Addendum #3

Project Name: Indiana State University – Dreiser Hall Renovation

Project #: 19052

Date: June 26, 2020

1 Floor Plan
Basement Plan
A1.00 1/8" = 1'-0"

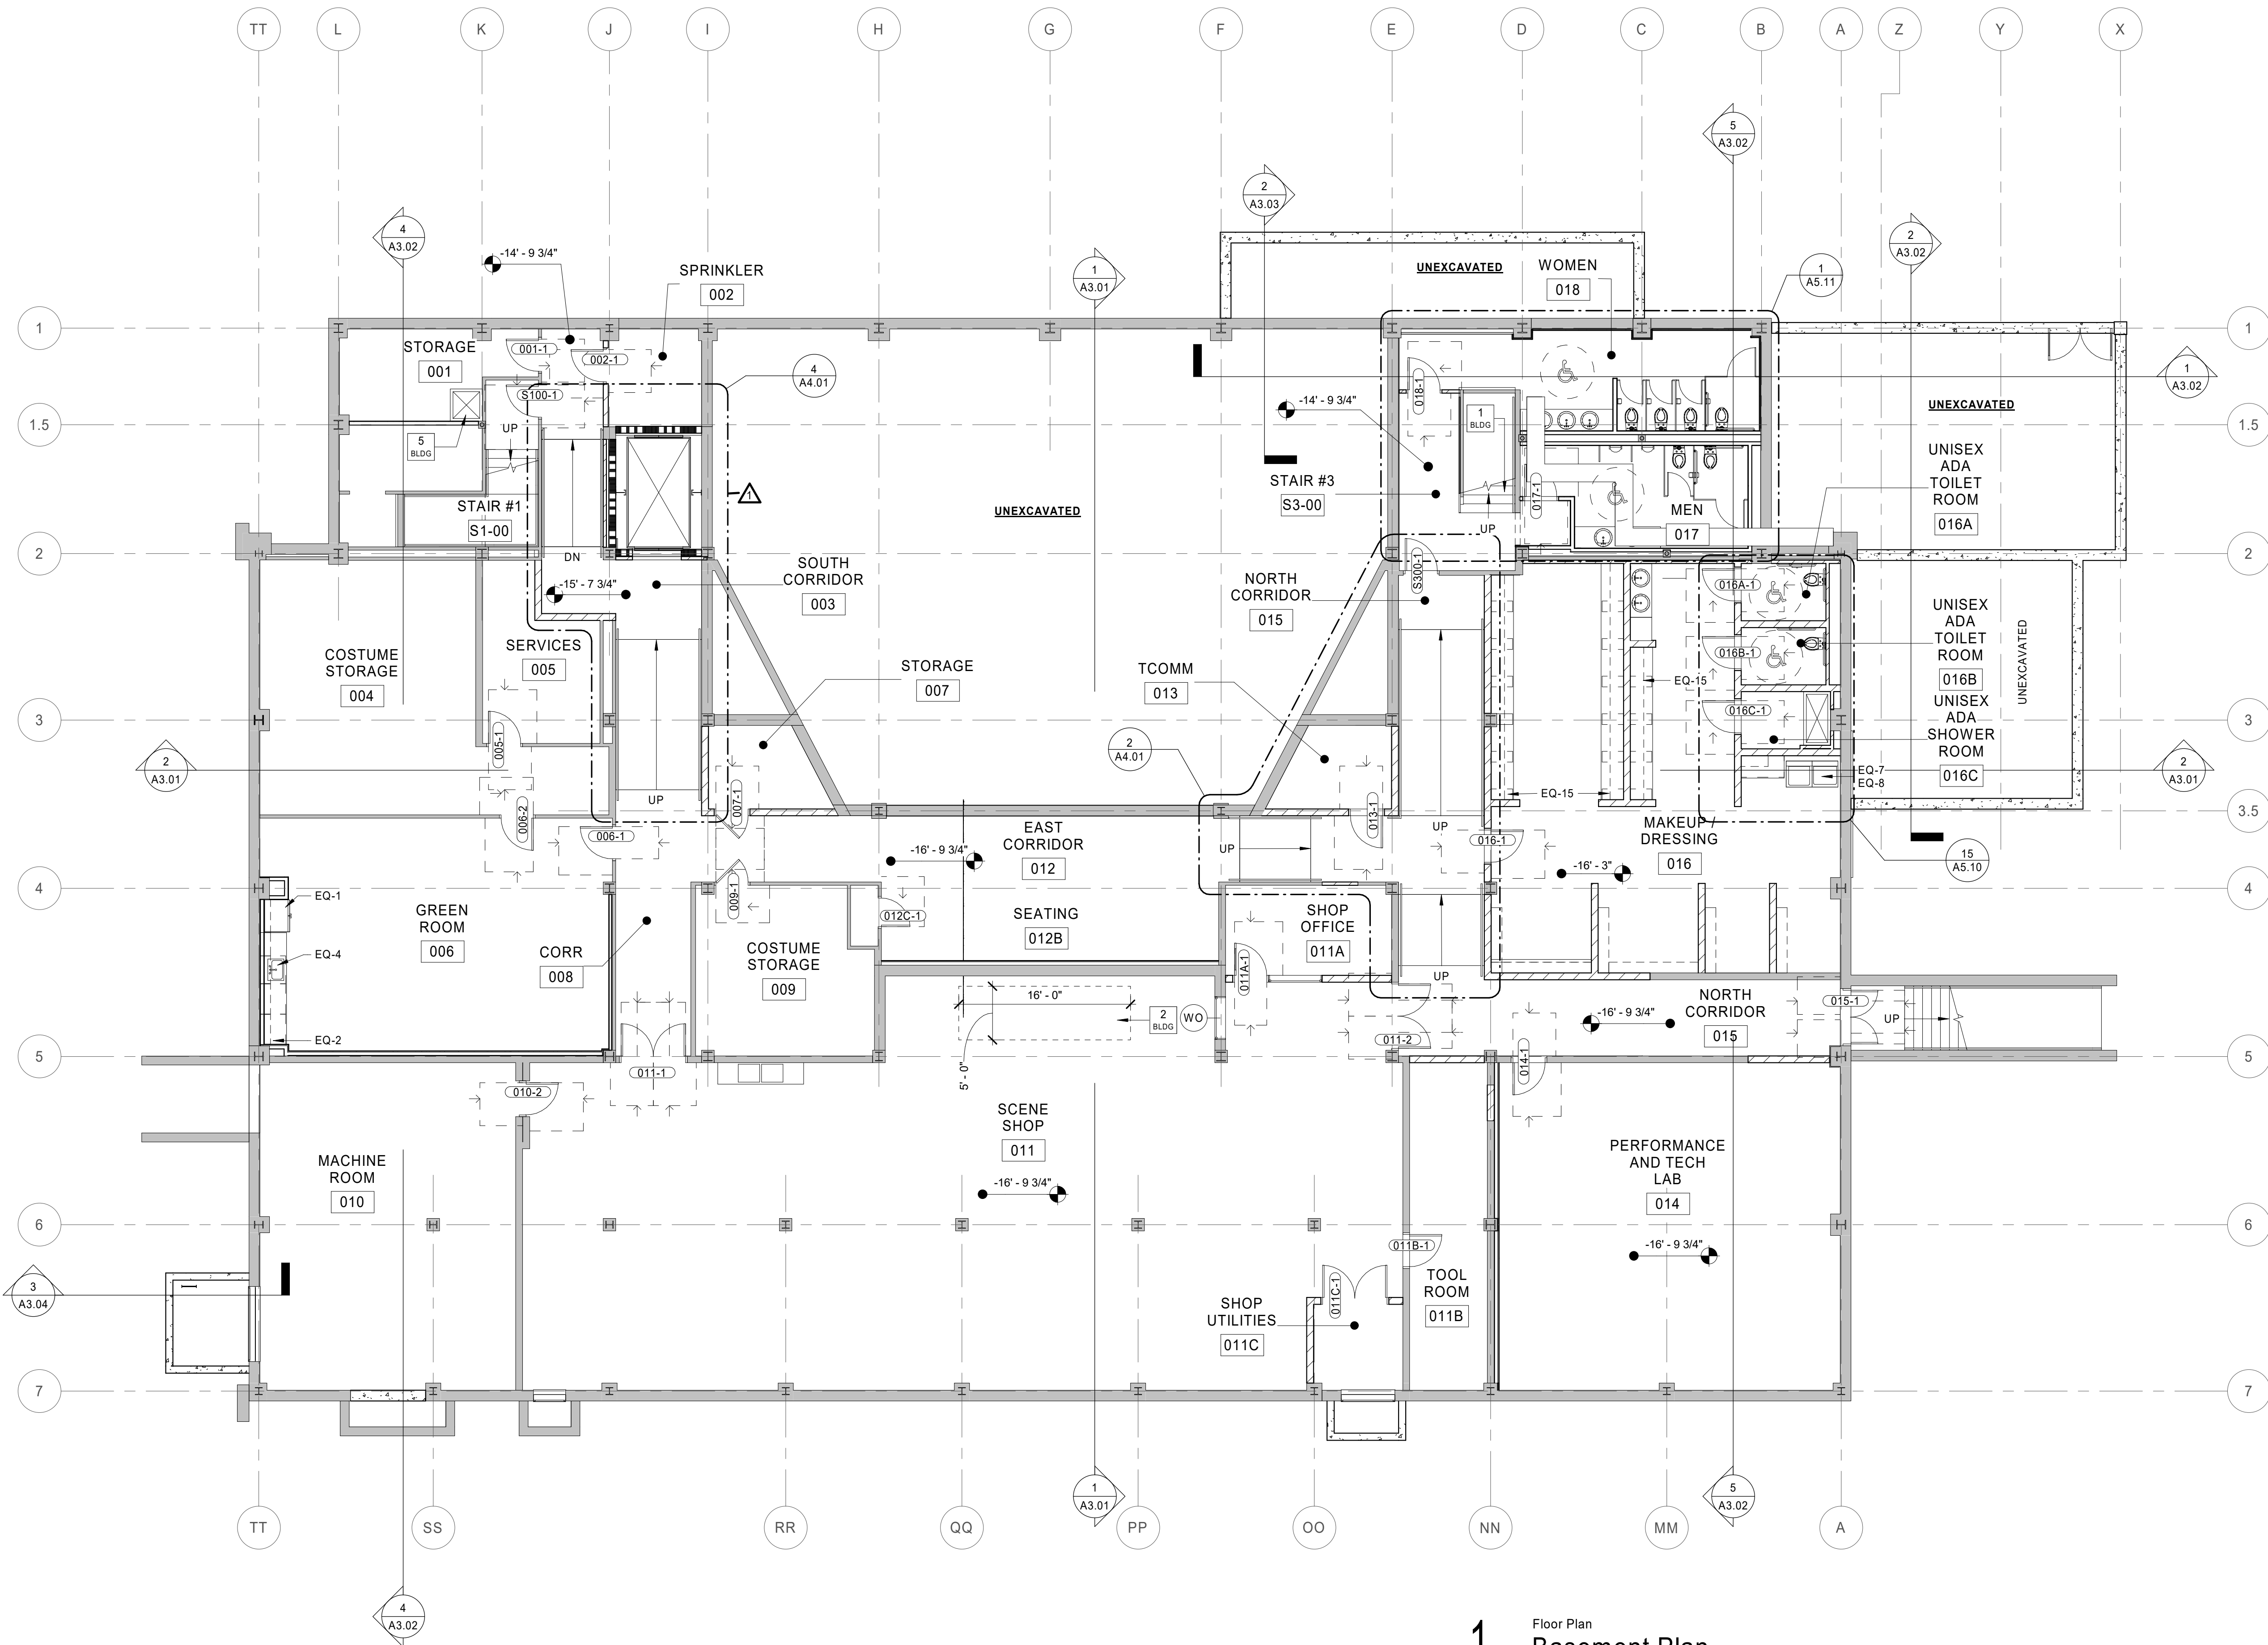
12. Sheet A1.00 – Basement Floor Plan
 - A. Reissue sheet – see clouds
 - B. Revised Coded Notes
13. Sheet A1.00B – Basement Reflected Ceiling Plan
 - A. Revise Coded Ceiling Note 5. to read: “ALTERNATE #4 – PROVIDE PIPE GRID CEILING AND THEATRICAL LIGHTING. SEE ELECTRICAL DRAWINGS FOR

1 Floor Plan
First Floor Plan
A1.01 1/8" = 1'-0"

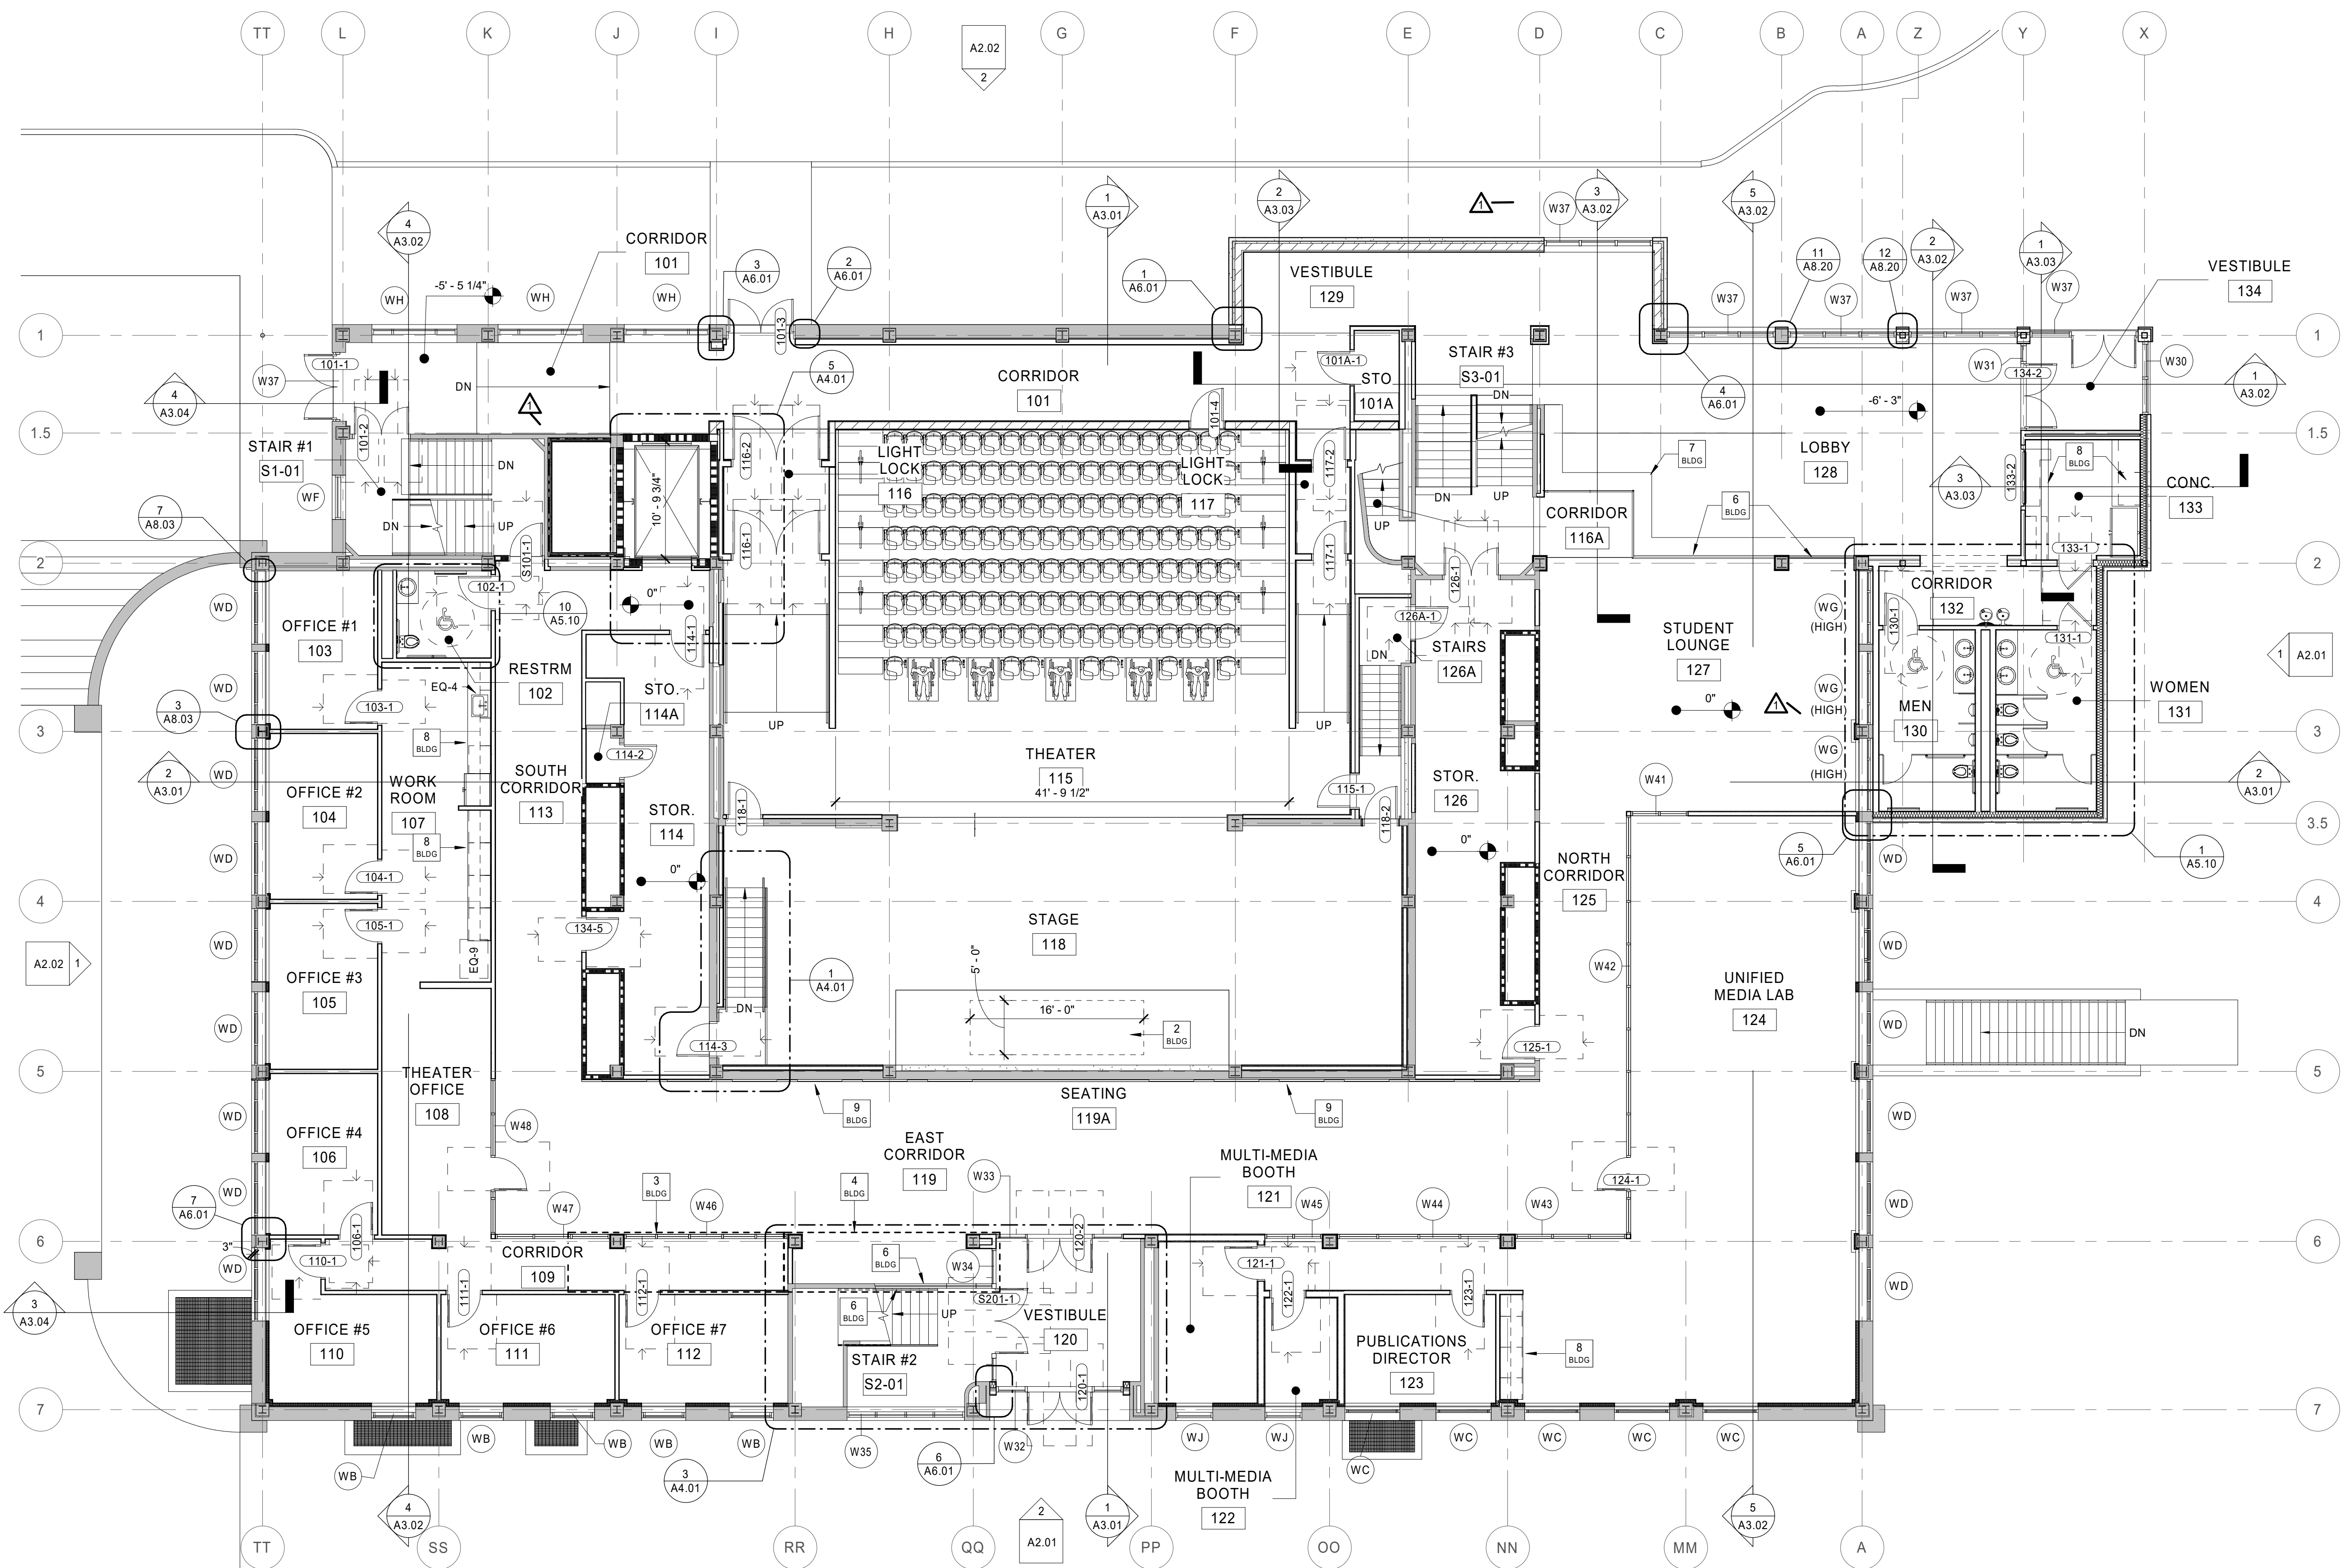
- C. Revise Coded Ceiling Note 16 to read: “METAL PANEL CEILING SYSTEM TO MATCH METAL PANELS.
14. Sheet A1.01 – 1st Floor Plan
- A. Reissue sheet – see clouds

- B. Revised Coded Notes
15. Sheet A1.01B – First Floor Reflected Ceiling Plan
- A. Revise Coded Ceiling Note 5. to read: “ALTERNATE #4 – PROVIDE PIPE GRID CEILING AND THEATRICAL LIGHTING. SEE ELECTRICAL DRAWINGS FOR MORE DETAILS. BASE BID – NO PIPE GRID OR THEATRICAL LIGHTING. PROVIDE THEATRICAL CURTAIN.

1 Floor Plan
2nd Floor Plan
A1.02 1/8" = 1'-0"

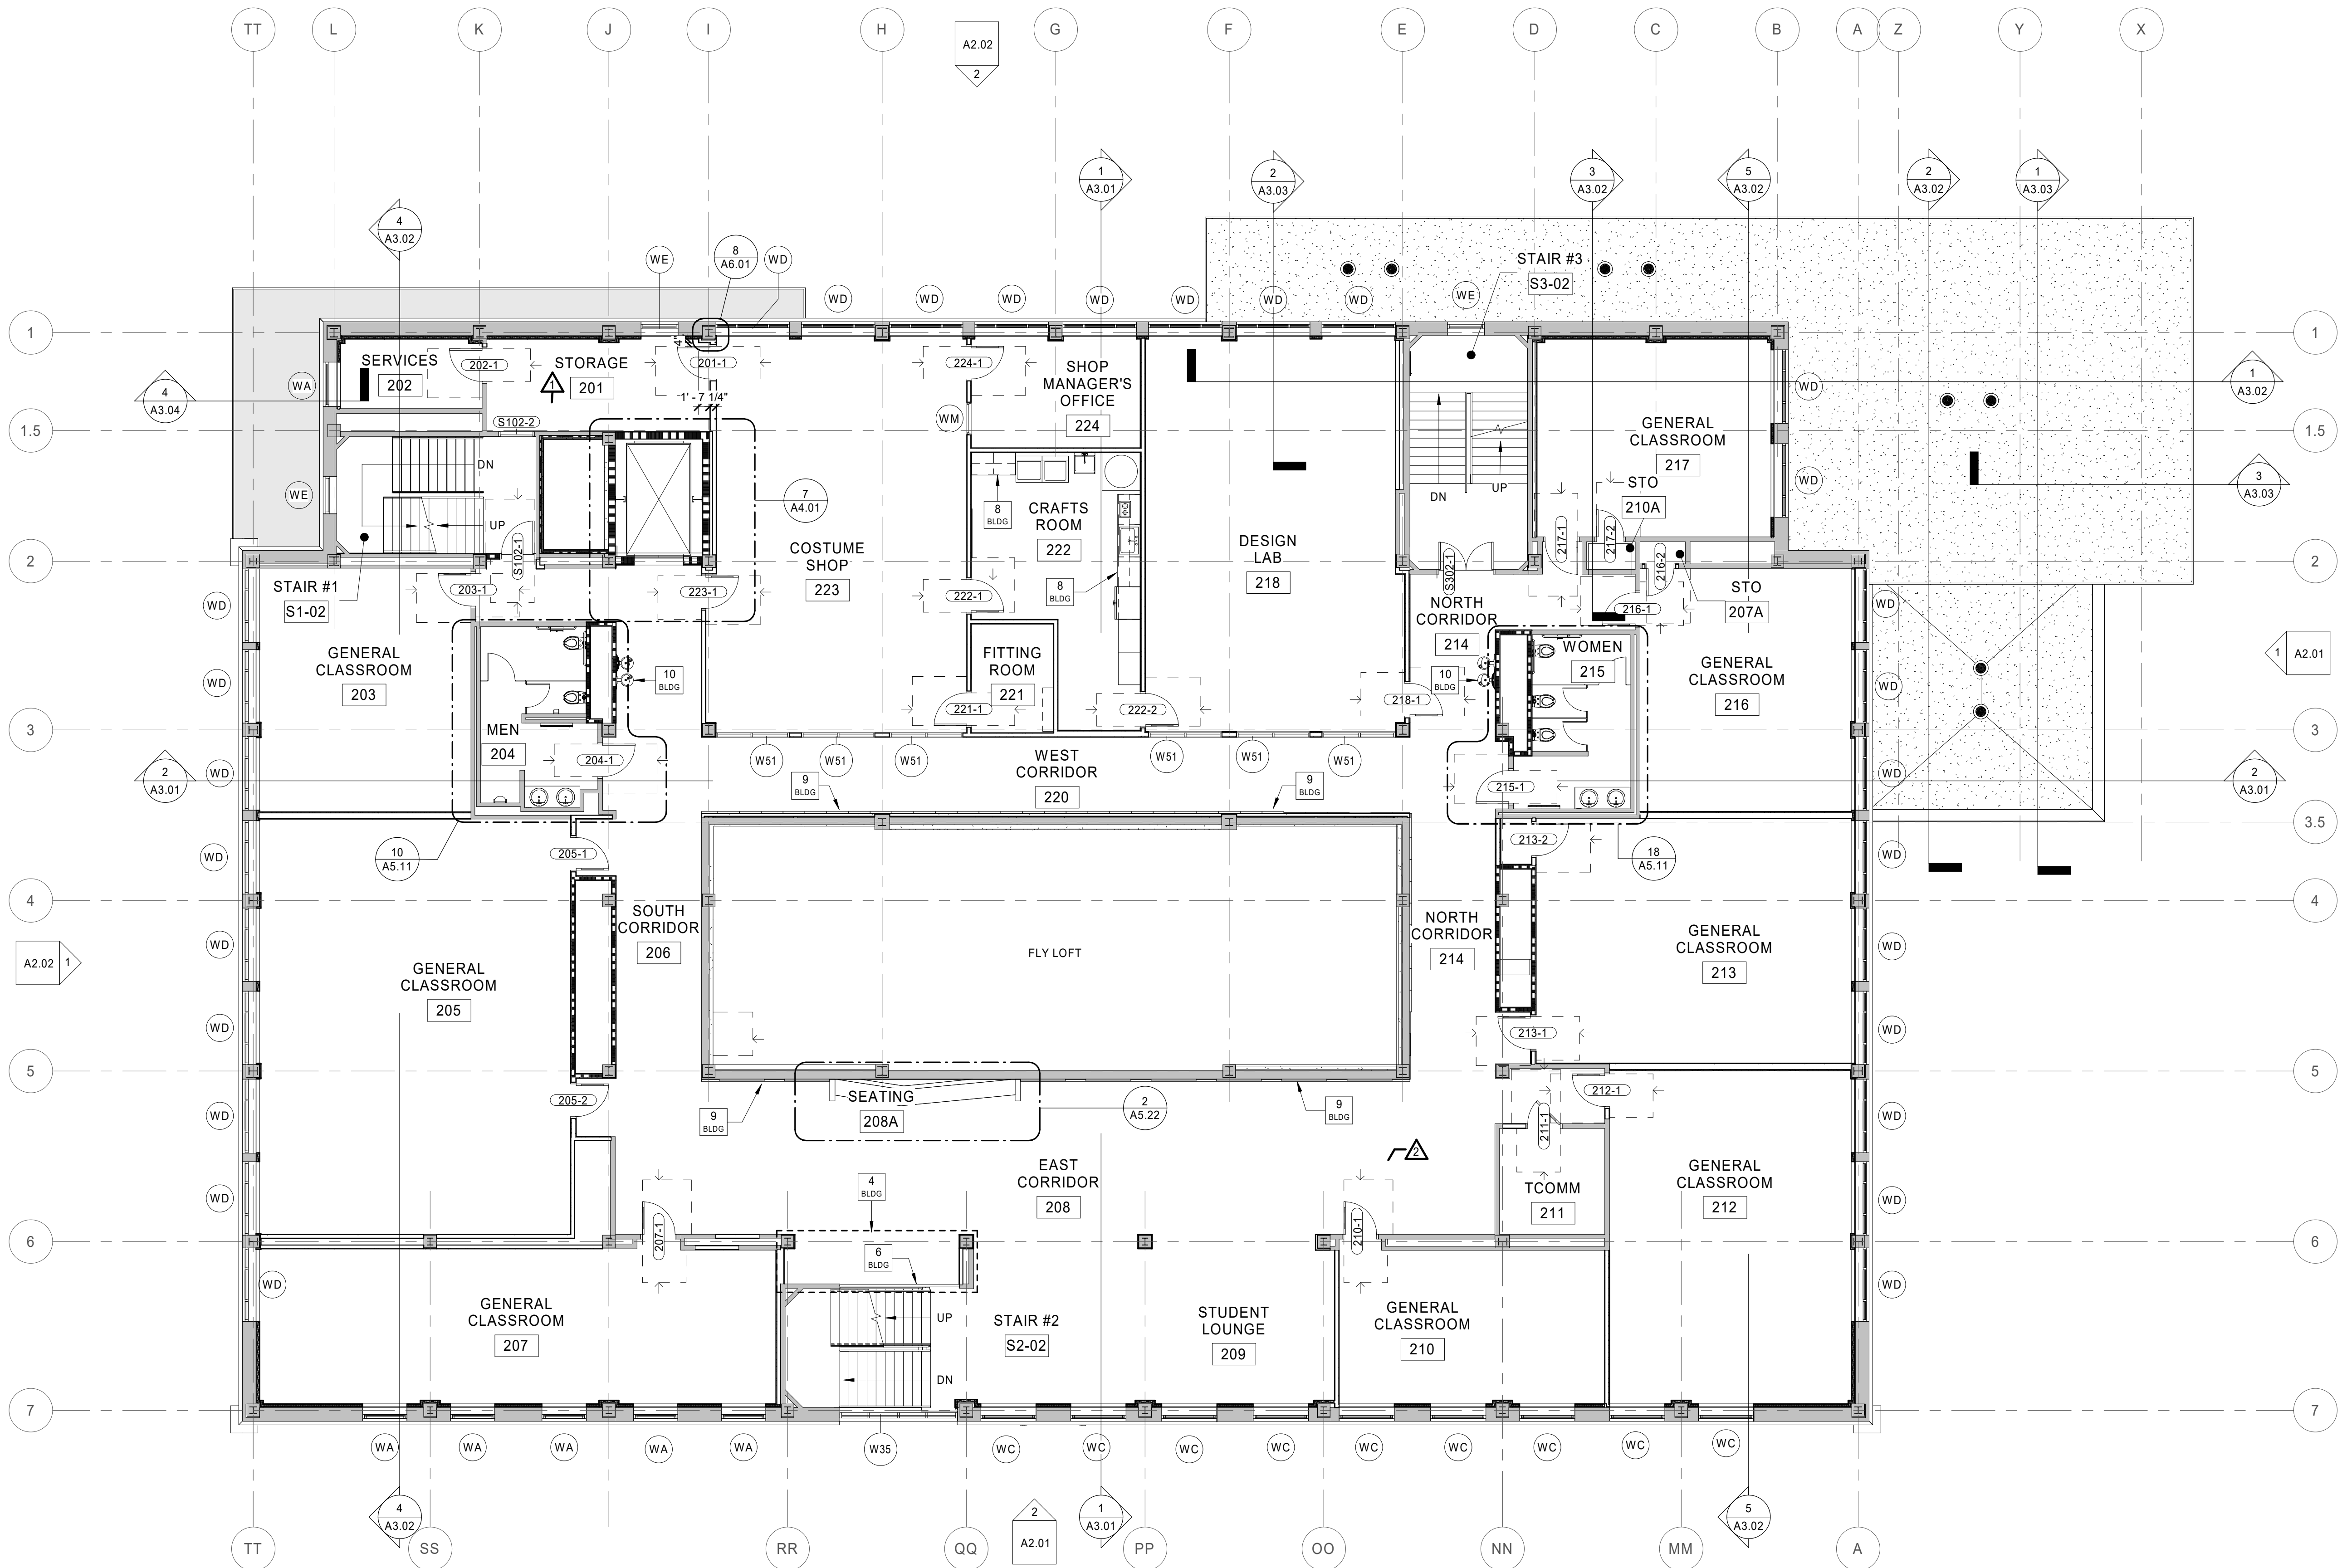
16. Sheet A1.02 – 2nd Floor Plan
- A. Reissue sheet – see clouds
- B. Revised Coded Notes
17. Sheet A1.02B – 2nd Floor Reflected Ceiling Plan
- A. Revise Coded Ceiling Note 5. to read: “ALTERNATE #4 – PROVIDE PIPE GRID CEILING AND THEATRICAL LIGHTING. SEE ELECTRICAL DRAWINGS FOR MORE DETAILS. BASE BID – NO PIPE GRID OR THEATRICAL LIGHTING. PROVIDE THEATRICAL CURTAIN.
